Midtown Ravines Group

**RE: CC34.7 - 847-855 Kingston Road
- Ontario Land Tribunal Hearing - Request for Directions**

847-855 Kingston Road

GROUND FLOOR PLAN

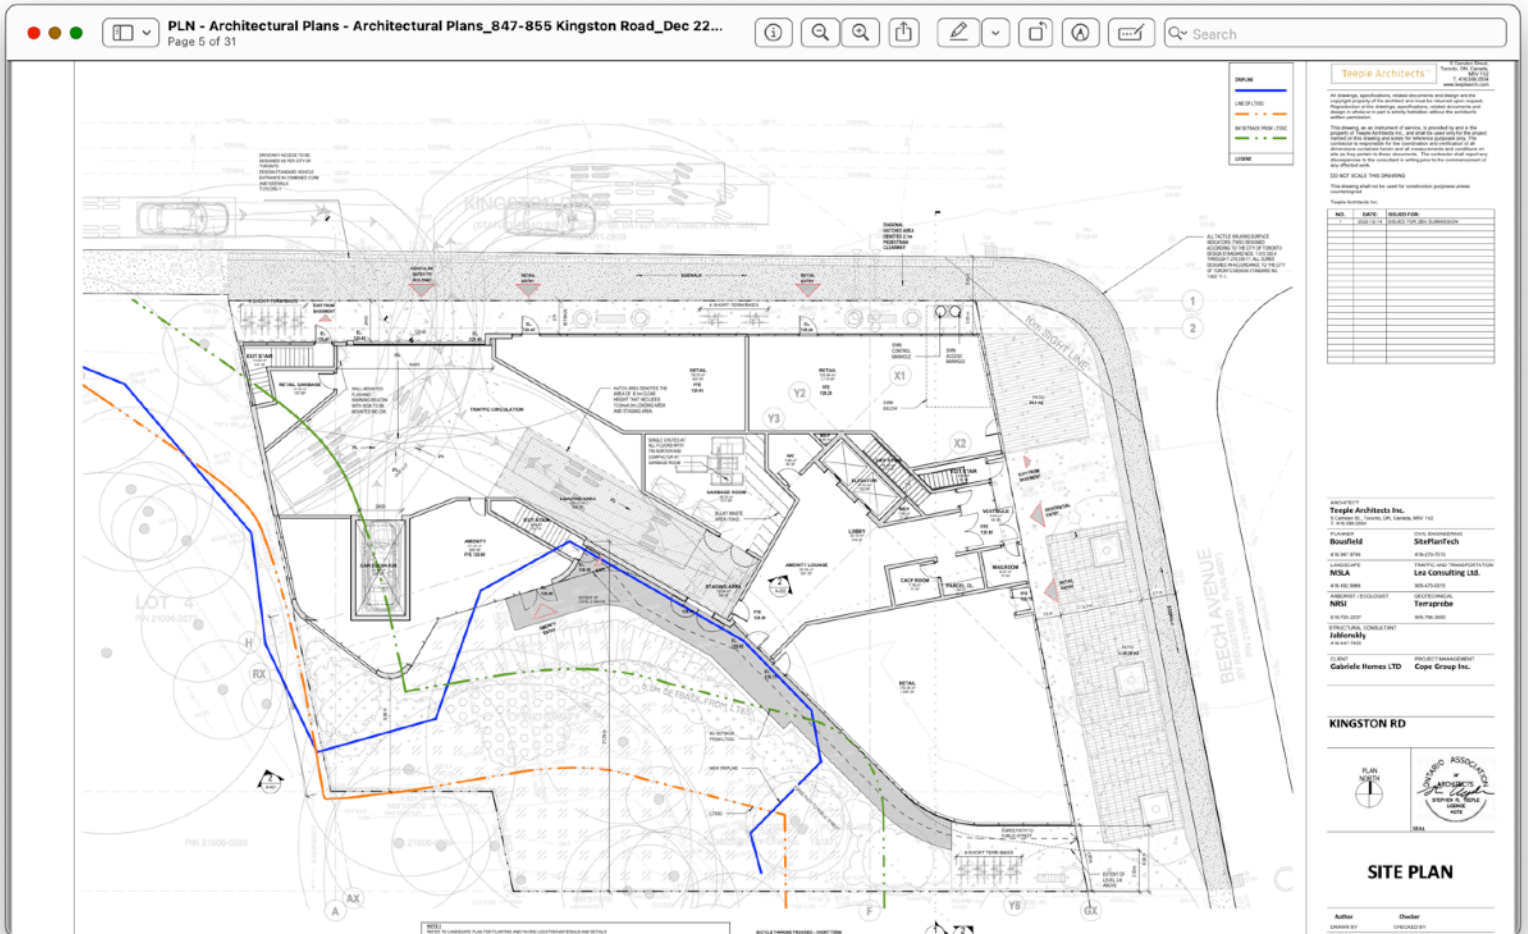
Attached is the ground floor plan for the proposed development, copied from page 5 of the Architectural Plans for the application at the City's Application Information Center. As you can see from the plan, the only publicly available information on the application shows a floor-plate substantially in excess of the floor-plate of the existing buildings on the site, excavated and built right up to the edge of the ravine slope on the west side of the development and built up to within 6 meters of the top-of-slope in the southeast part of the ground floor.

The dashed red line is the LTSSC (Line of Top of Stable Slope Crest).
 The dashed green line is a 6 meter setback from the LTSSC

As you can see, the proposed development is built (and excavated) right up to the LTSSC on the western side of the proposed construction and right up to within 6 meters of the LTSSC on the east.

This is an egregious violation of the 10-meter setback rule.

We urge you to **reject any settlement that violates the ten-meter-setback rule** and ask that you provide all necessary expert resources to defend the setback rule at the OLT.
